Questions & Answers

7th Street Grade Separation East Project (7SGSE)

Community Briefing & Listening Session

Hosted by Alameda County Transportation Commission in
Collaboration with the Port of Oakland

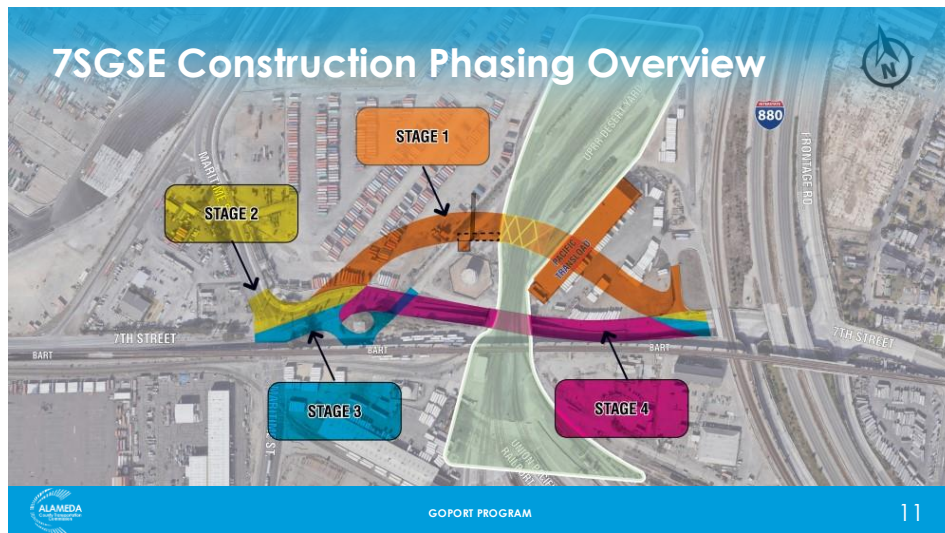
2. How is the connection made between Bay Street and 7th Street?

The Bay Street and Maritime Street connections will generally connect at the same points on 7th Street with minor adjustments to meet design standards, similar to what is present today. The new 7th Street roadway alignment will be constructed along the orange shaded area as shown below. Our work includes building new retaining wall systems for the new roadway and new bridge structures for UPRR track facilities.
